CITY OF SALEM

Written Testimony #1

4.a. [20-338](#) Public Hearing on Amendment to Salem's Stormwater Master Plan.

7.1a. [20-339](#) Amendment to Salem's Stormwater Master Plan.

A Design Storm as stated in SRC 70.005 Definitions

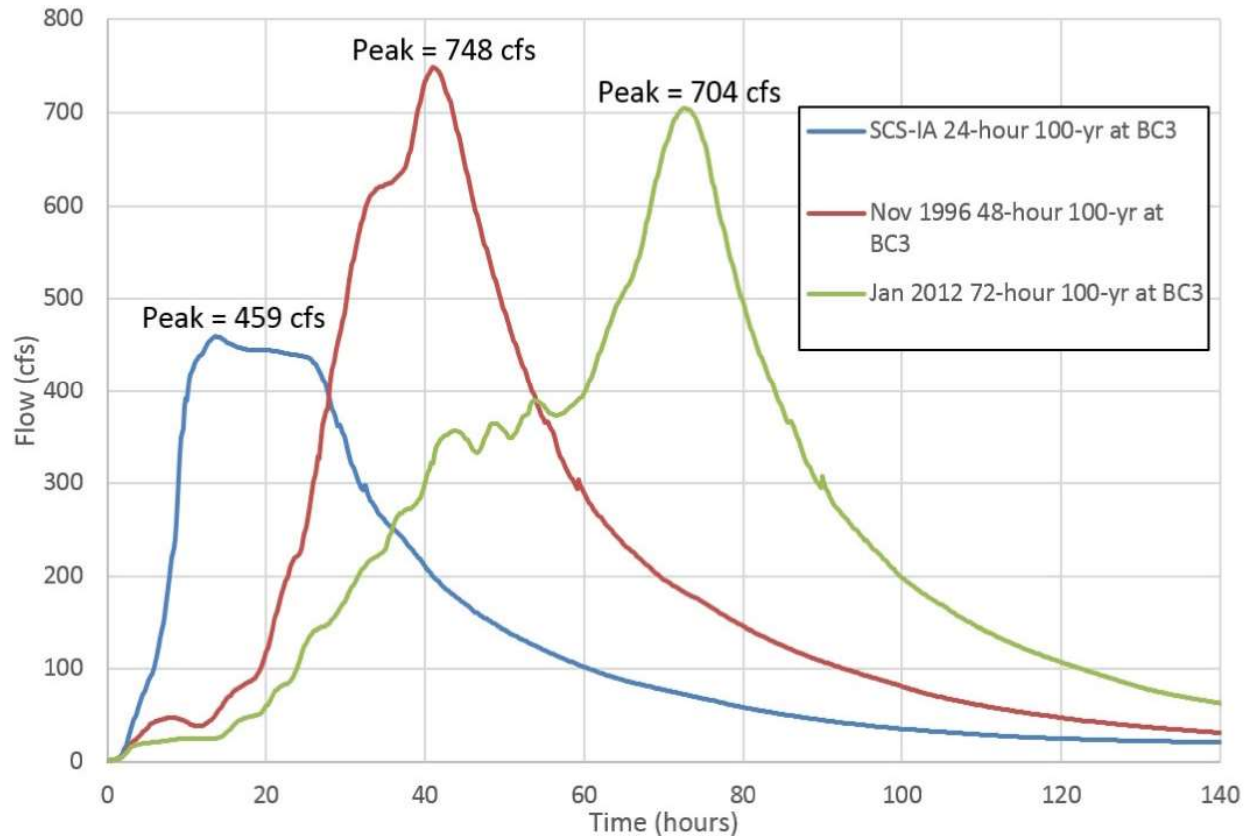
This claim contradicts conversations I conducted with FEMA representatives. During my discussion with FEMA staff regarding the utility of a 24-hour design storm in connection with CRS, I learned that such a standard is not specified. Any and all methodologies are considered that can be shown to have positive impact on the control of pre and post development stormwater runoff. FEMA’s intent is to limit and reduce the risk of flooding. If a “Standard” has been shown to be not effective it is up to the community to develop methods that demonstrate results, and then clearly show FEMA how the solution will work. Certainly, in some jurisdictions a 24-hour Design Storm works. Where it does not, it cannot be relied upon. **Salem is one of those communities where the 24-hour design storm does not work.**

A “synthetic rainfall distribution” has been used in Salem well before the Councils approval of SRC 71. It has been used as a tool to help engineers identify a metric for “synthetic” rainfall and to help calculate the volume of stormwater in a given place for a defined amount of time.

The problem: The 24-hour design storm standard is not the tool to be used in the Pacific NW, nor in Salem Oregon.

The State of Washington has learned that the 24-hour design storm does not provide a safe metric. Washington has directed communities to review their use of the tool. The City of Seattle and King County have already moved into the 21st century and are now using “continuous flow modeling”. Our State of Oregon has this same issue under review. Salem has pursued own efforts to understand why homes along the streams of Battlecreek, Mill Creek and the other 10 Salem Stormwater basins flood during winter storm events.
